National Highway Traffic Safety Administration

Federal Motor Vehicle Safety Standards; Platform Lifts for Motor Vehicles; Platform Lift Installations in Motor Vehicles

ACTION: Notice of proposed rulemaking (NPRM); grant in part, denial in part of petitions for rulemaking.

FIGURE 2

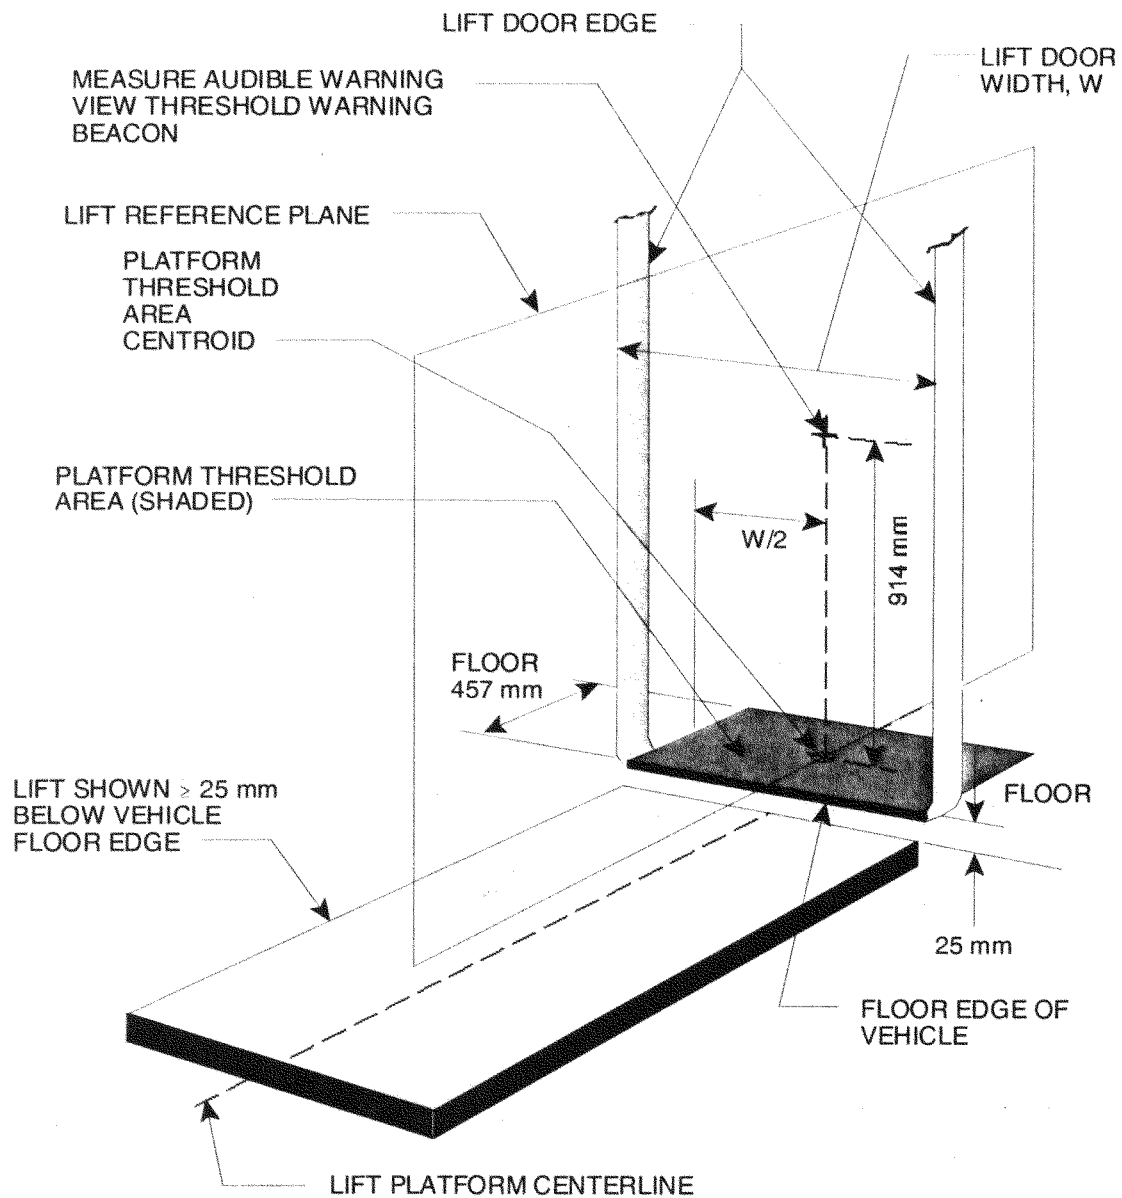
B. Correct Figure 2 in FMVSS No. 403 To Make it Consistent With the Threshold Beacon Warning Requirements in S6.1.6

It has come to NHTSA's attention that a dimension in Figure 2 is incorrect. The height of the measurement point from which the intensity of the threshold audible warning is measured and the threshold warning beacon must be visible is identified as 919 mm. Because S6.1.6 provides that this measurement point is 914 mm (3 feet), we are proposing to replace Figure 2 with revised Figure 2, which shows a measurement point of 914 mm (3 feet), consistent with the requirements of S6.1.6.

S6.1.6 The intensity of the audible warning and visibility of the visual warning required by S6.1.2 and S6.1.3 is measured/observed at a location 914 mm (3 ft) above the center of the platform threshold area. (See Figure 2).
